# Work Order ID 89418

Item Name: Crosstube Aft

DRAWING NO. D412-664-243	TITLE CROSSTUBE ASSEMBLY (412 HI AFT)	REV. E	DART AEROSPACE LTD ENGINEERING ORDER		D.E.O. NO. D412-664-243-E-1	SHEET NO. SHEET 1 OF 2	SCALE NTS
DRAWN	CHECKED <i>MP</i>	MFG. APPR. <i>E</i>	APPROVED <i>MP</i>		DE APPR. <i>MP</i>		
DATE 11.03.31	DATE 11/03.31	DATE 11.03.31	DATE 11/03.31		DATE 11.03.31

DRAWING NO. D412-664-243	TITLE CROSSTUBE ASSEMBLY (412 HI AFT)	REV. E	DART AEROSPACE LTD ENGINEERING ORDER		D.E.O. NO. D412-664-243-E-4	SHEET NO. SHEET 1 OF 3	SCALE NTS
DRAWN 97	CHECKED A	MFG. APPR. A	APPROVED MP		DE APPR. MP		
DATE 12.08.21	DATE 12.08.30	DATE 12.08.30	DATE 12/8/30		DATE 12.08-30

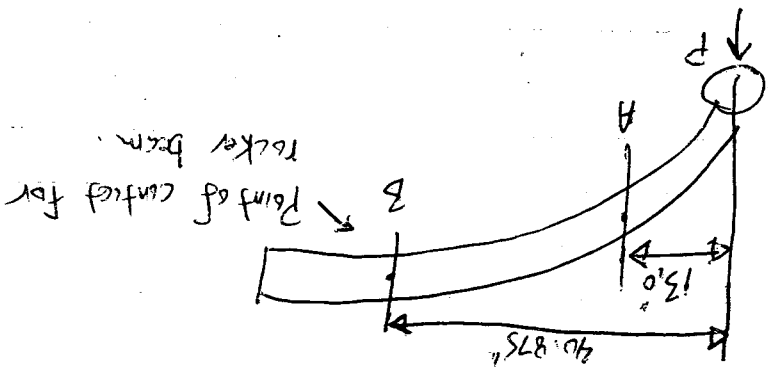
REPLACE MAGNOBOND WITH 3M DP460 SCOTCH-WELD EPOXY ADHESIVE

NOTE 12 & 16, SHEET 1 IS AMENDED AS FOLLOWS:

WAS:

- 12) INSTALL D2896-1 SUPPORT USING 0.03" TO 0.06" THICK LAYER OF MAGNOBOND 6398 TO THE SURFACE OF D2896-1 THAT WILL BE IN CONTACT WITH THE CROSSTUBE PER QSI 015. LET CURE FOR 12 HOURS AFTER INSTALLATION AND PRIOR TO PACKAGING.
- 16) TORQUE CLAMPS 80 TO 100 IN-LB. ENSURE AT LEAST 1.5 THREADS SHOWING IN SAFETY AND THAT NUT HAS NOT BOTTOMED-OUT AFTER TORQUING.

- 12) INSTALL D2896-1 CENTER SUPPORT USING A 0.04" TO 0.07" THICK LAYER OF SCOTCH-WELD DP460 PER QSI 015. LET CURE FOR 24 HOURS AFTER INSTALLATION AND PRIOR TO PACKAGING.
- 16) TORQUE CLAMPS 80 TO 100 IN-LB. ENSURE AT LEAST 1.5 THREADS SHOWING IN SAFETY AND THAT NUT HAS NOT BOTTOMED-OUT AFTER TORQUING. **PRIOR TO PACKAGING, RE-CHECK TORQUE ON CLAMPS AFTER ADHESIVE HAS CURED FOR 24 HOURS.**

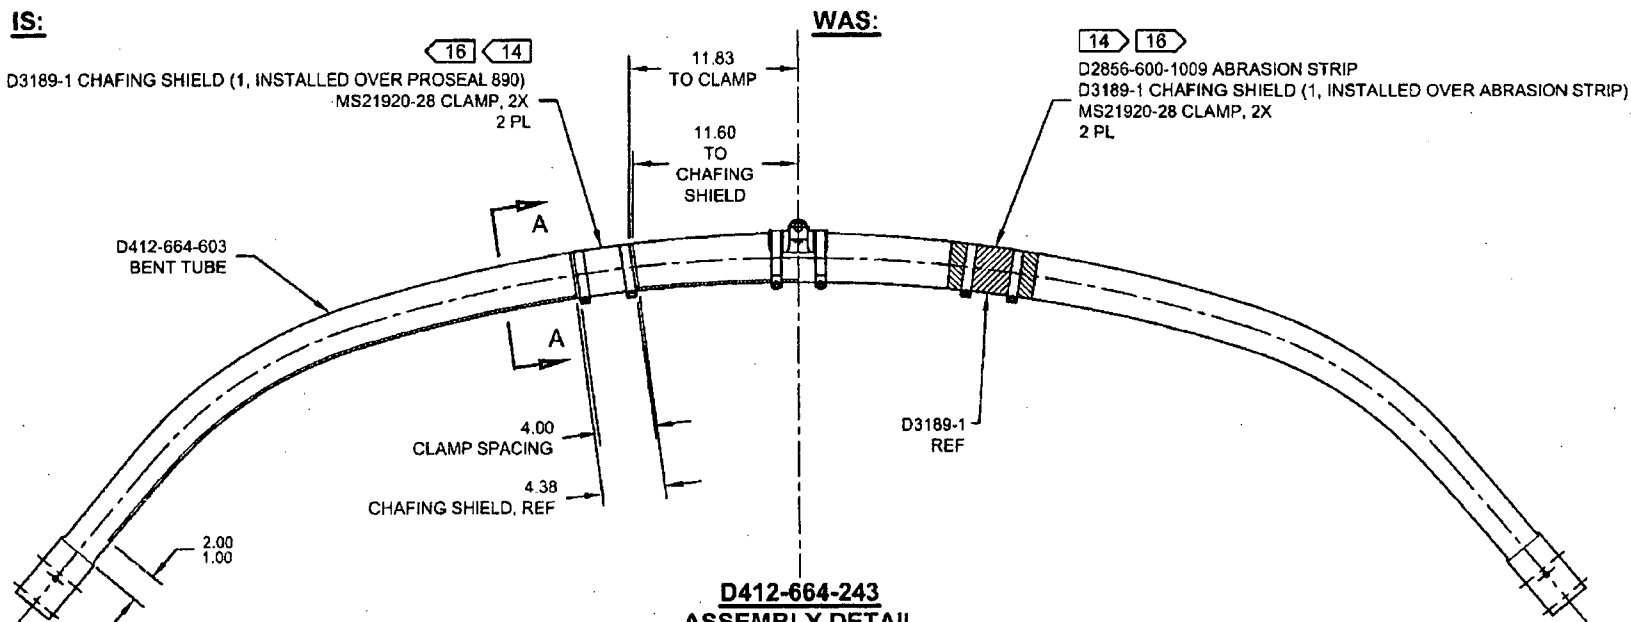
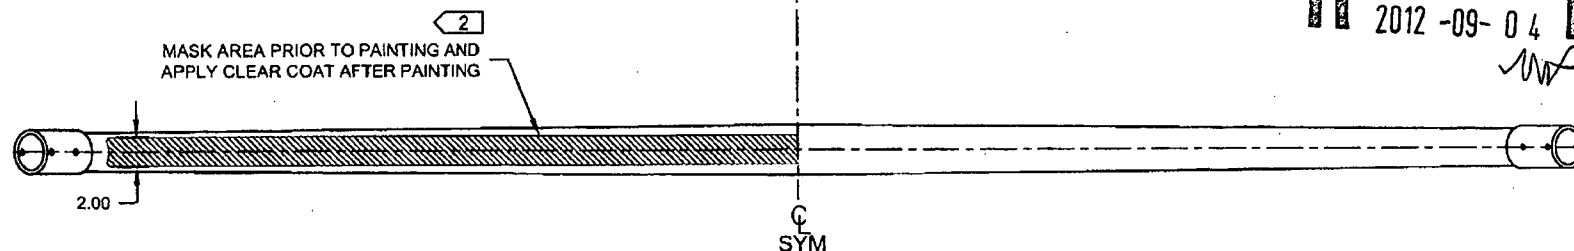
NOTES 2, 14, AND 16 ON SHEET 1 ARE AMENDED AS FOLLOWS:

**IS:**

D2856-600-1009 ABRASION STRIP  
D3189-1 CHAFING SHIELD (1, INSTALLED OVER ABRASION STRIP)  
MS21920-28 CLAMP, 2X  
2 PL

D3189-1  
REF

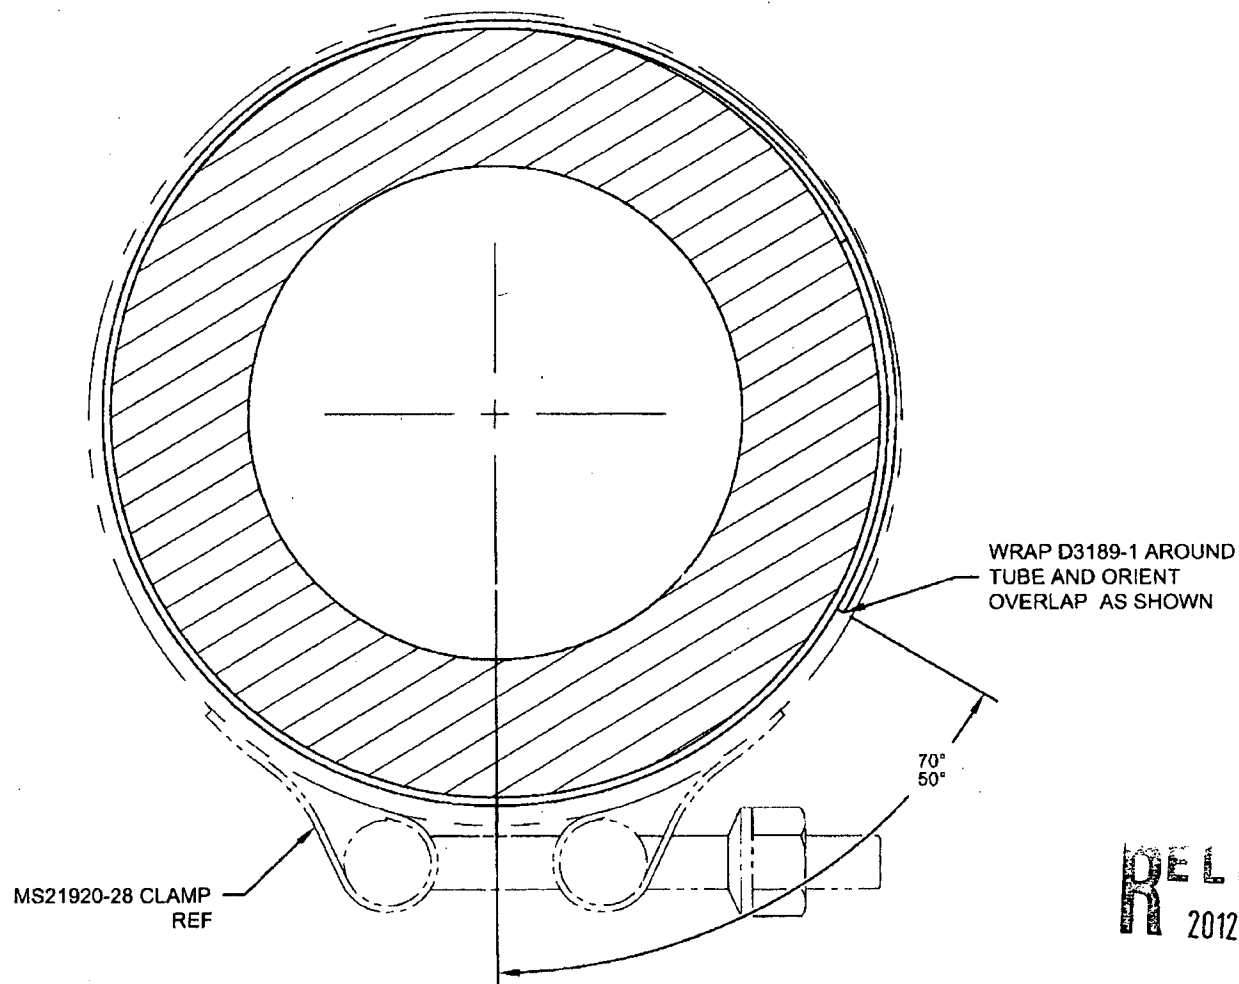
**SECTION A-A**  
CHAFING SHIELD DETAIL  
VIEW ROTATED, NOT TO SCALE
